# FINAL DRAINAGE PLAN AND REPORT

## 16140 OLD DENVER ROAD

PCD File No. PPR-16-037

SUBJECT: Drainage Plan and Report  
All About Outdoor Storage PPR-16-037

## Detention Basin Outlet Structure Design

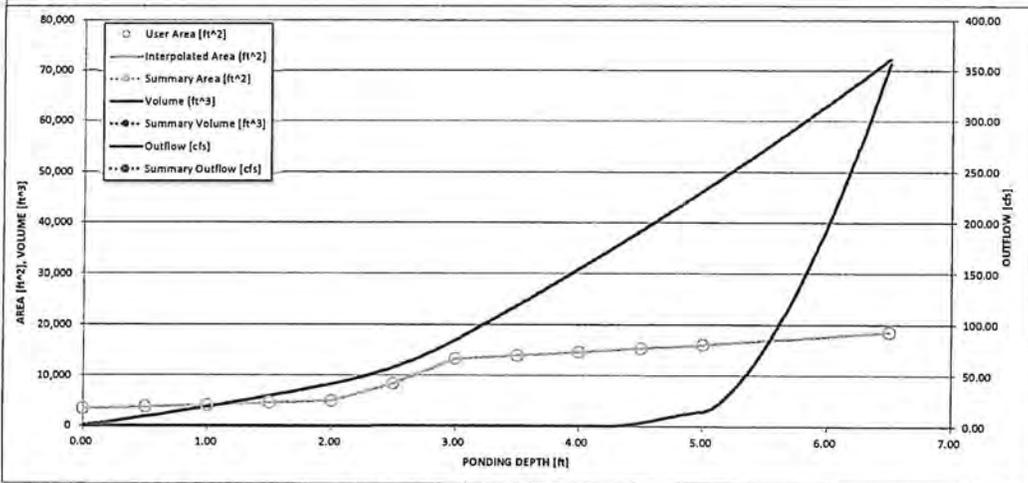
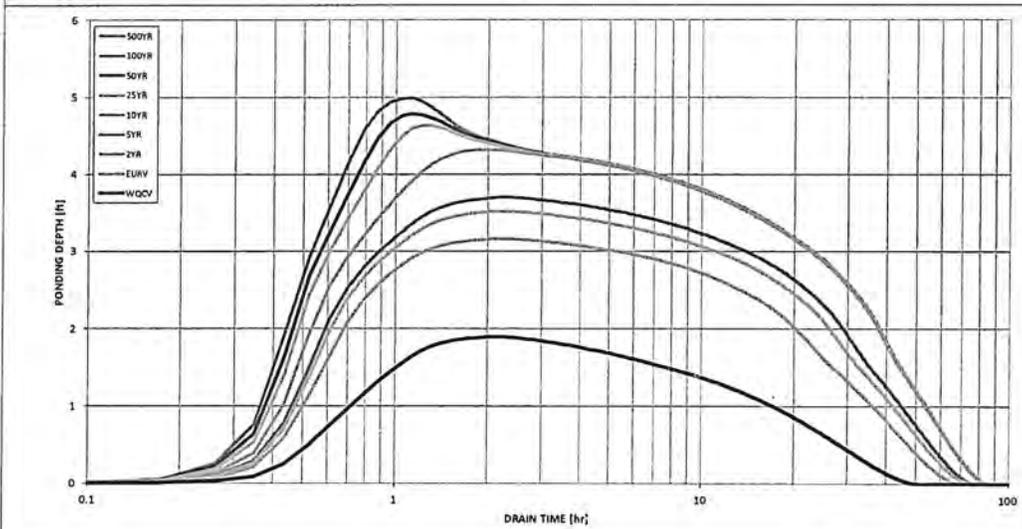
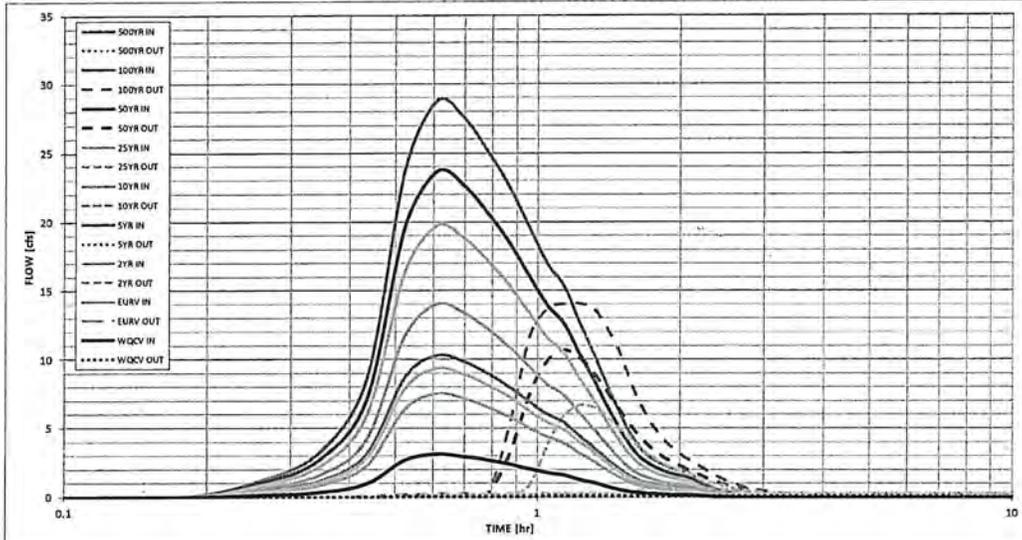
Revise Min width of structure to 4' for maintenance

Revise the outlet detail or this UD-Detention calculation to match. Details show a 3:1 sloped grate

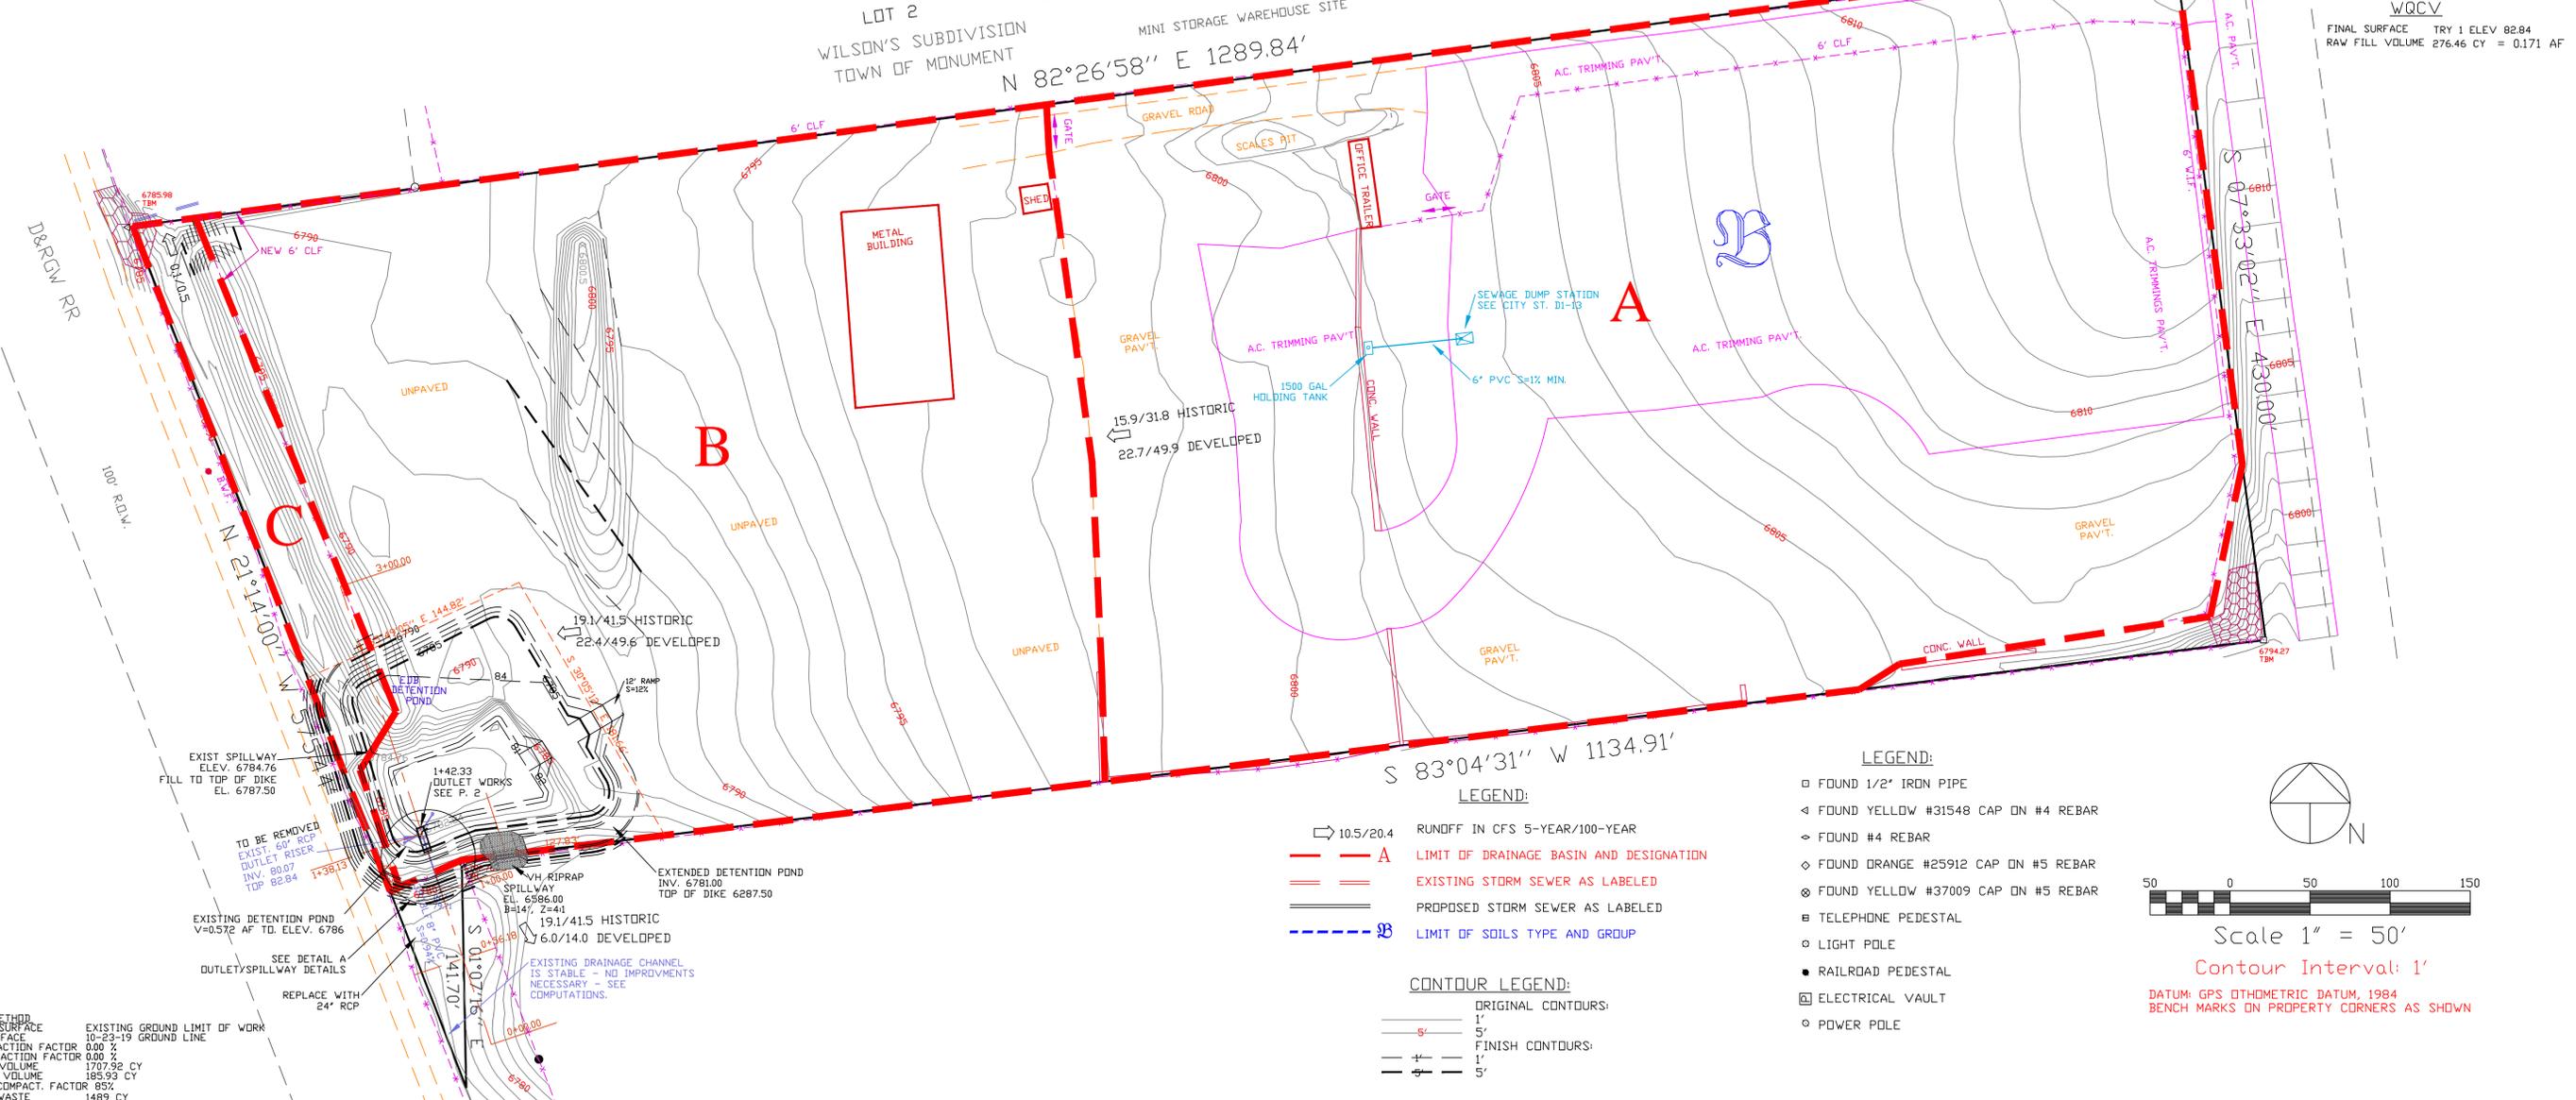
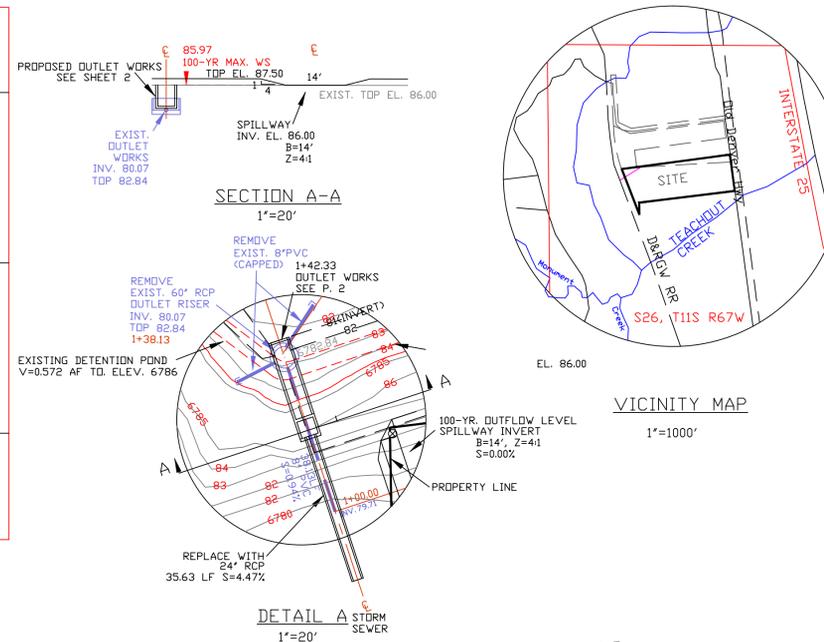
See the construction drawing for comments that needs to be incorporated in this drainage map
